RE: **Lot 37 Block 8, Volcano Cliffs, Unit 22, SAD 228
6431 Picardia NW
Grading and Drainage Plan
Engineers Stamp Date 3/2/20 (D10D003E37)**

DRAINAGE AND TRANSPORTATION INFORMATION SHEET (REV 6/2018)

ENGINEER'S SEAL	6431 PICARDIA NW	DRAWN BY WCVJ
	GRADING AND DRAINAGE PLAN	DATE 9-19-19
		2109076-LAYOUT-9-19-19
3/2/20	 <i>Rio Grande Engineering</i> 1606 CENTRAL AVENUE SE SUITE 201 ALBUQUERQUE, NM 87106 (505) 872-0889	SHEET # —
DAVID SOULE P.E. #14522		JOB # 2109076

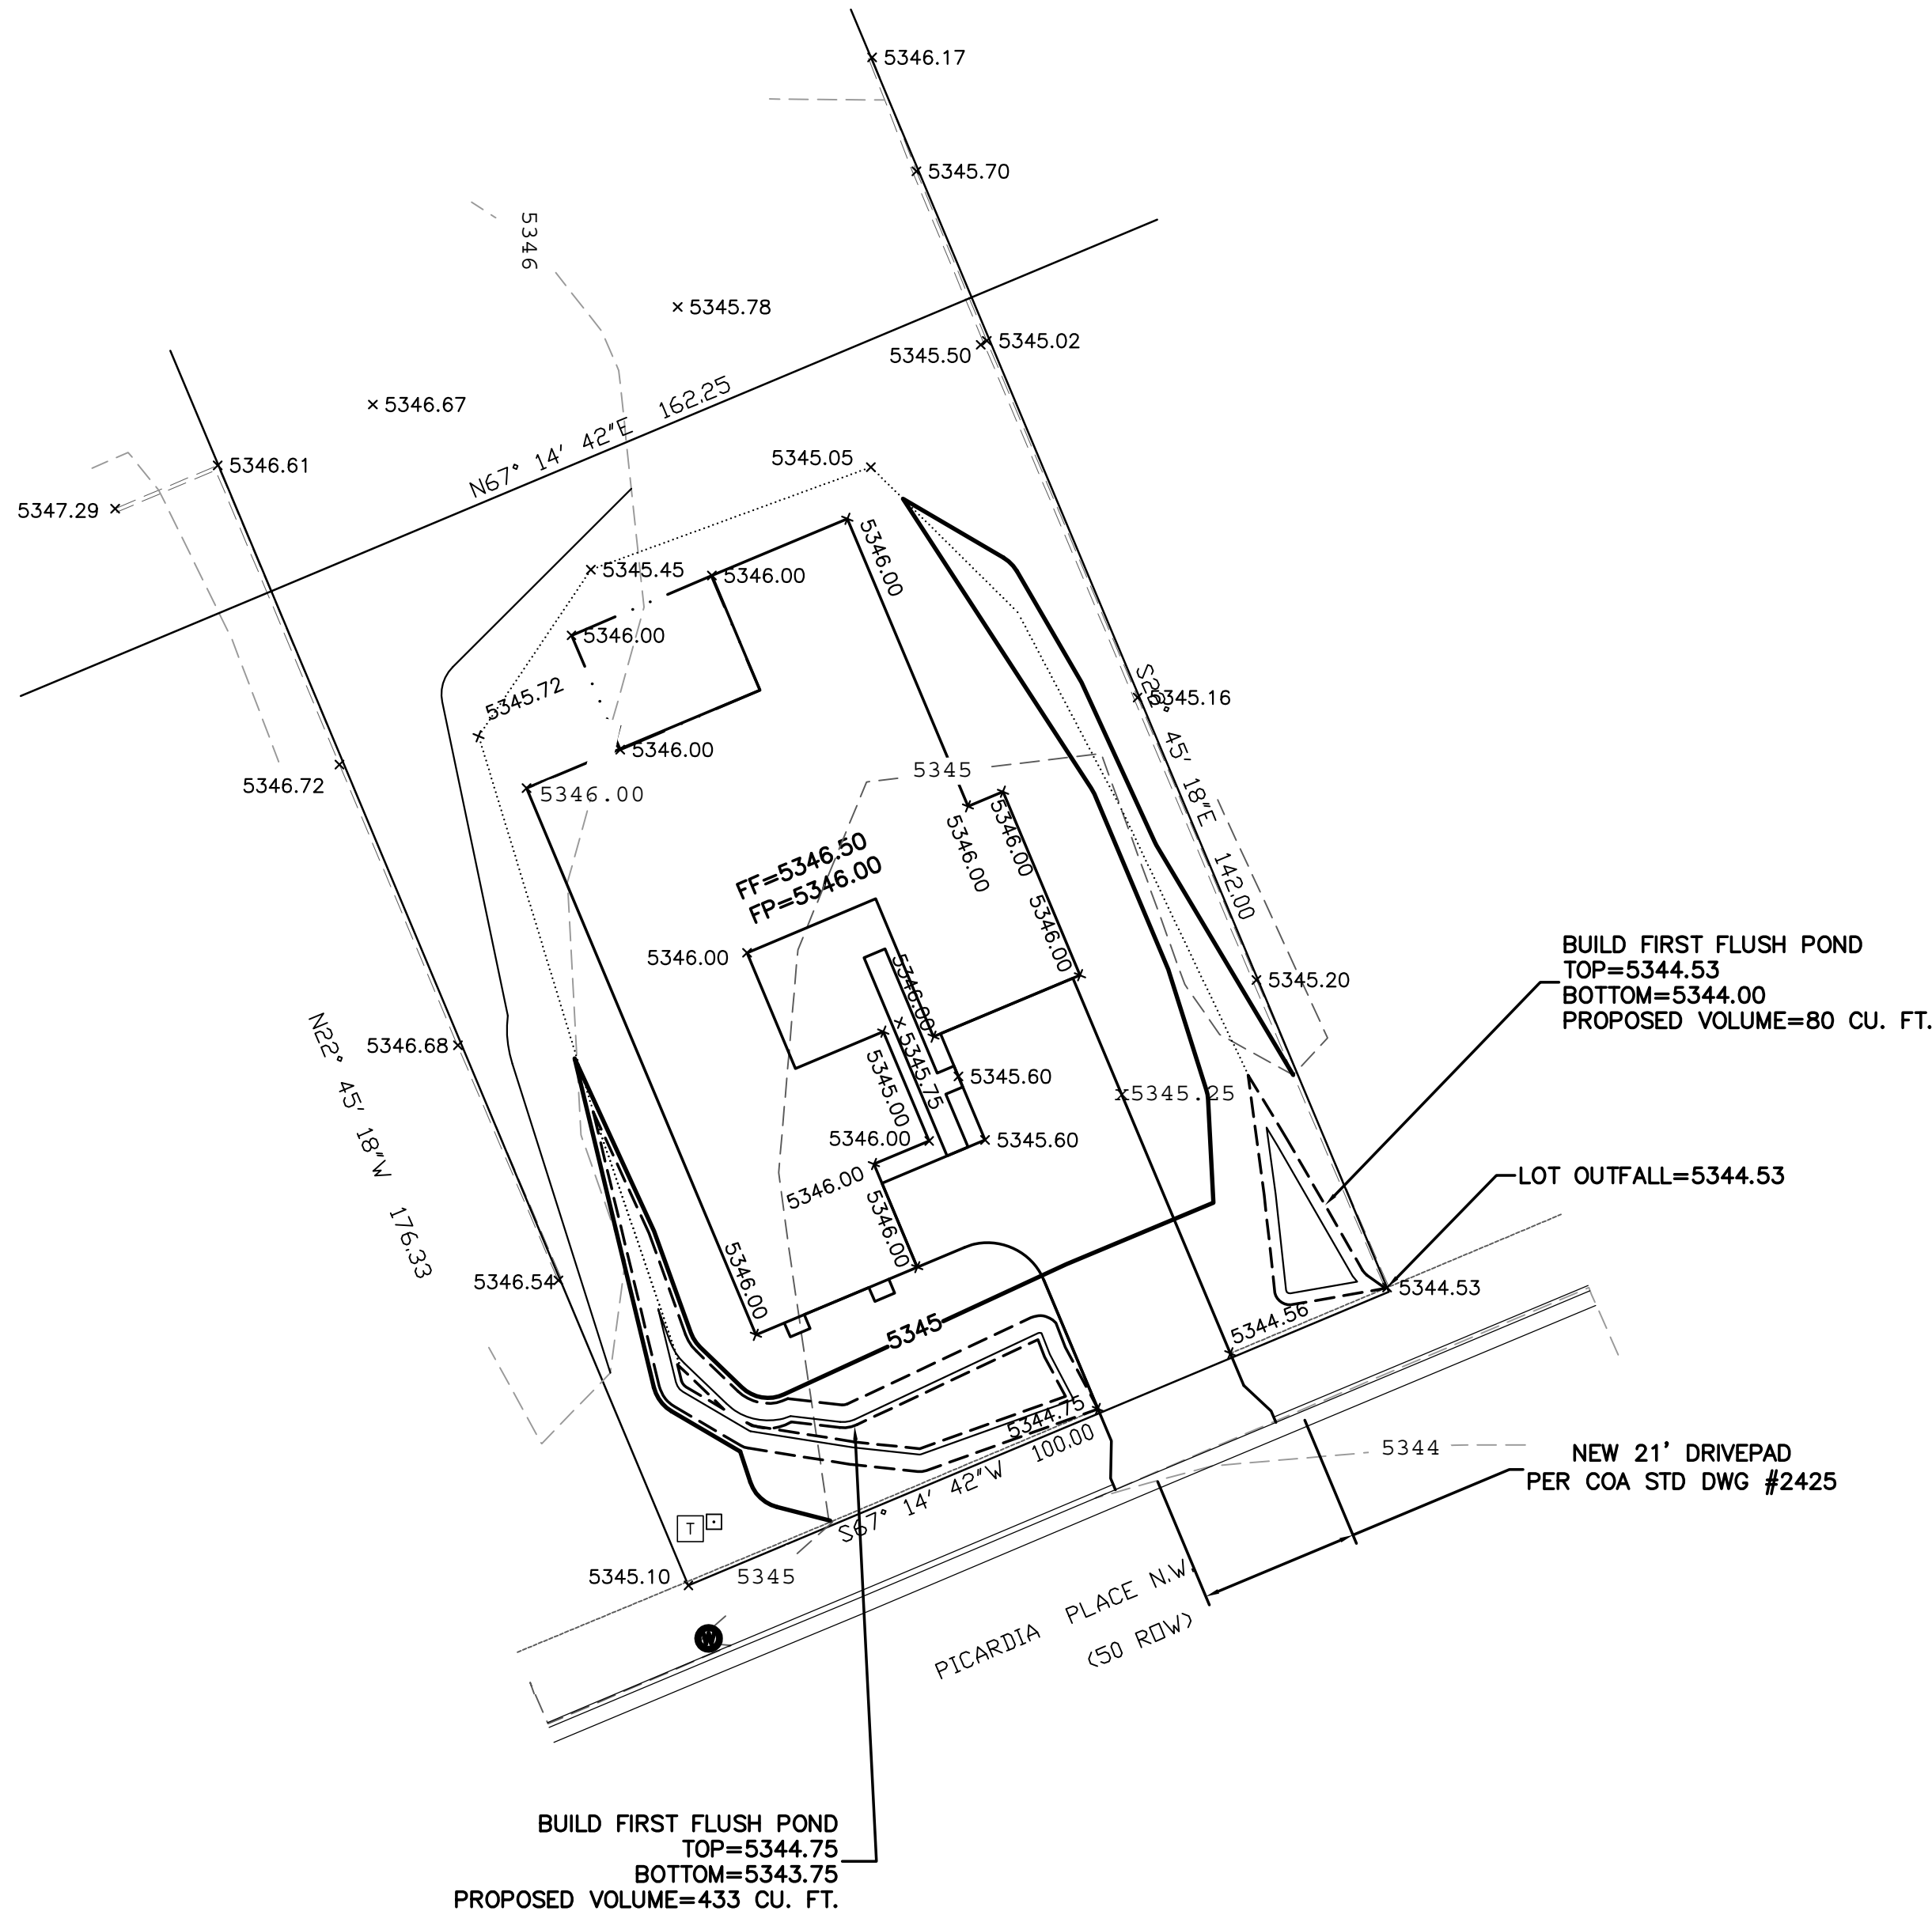
Based upon the information provided in your submittal received 3/3/20, this plan is approved for Grading Permit.

Prior to Building permit approval a Pad Certification will be required, provided by the Engineer or a registered Land Surveyor.

Advise the owner contractor not to use dirt as a ramp to climb the curb, use lumber or crusher fines for this purpose.

Reiterate to the Owner/Contractor that a separate permit for a garden/retaining wall must be obtained with the approved G&D plan and Pad Certification. Also, if a swimming pool is to be placed the grading and drainage plan will change and will need to be resubmitted.

Prior to Certificate of Occupancy release, Engineer Certification per the DPM checklist is required.
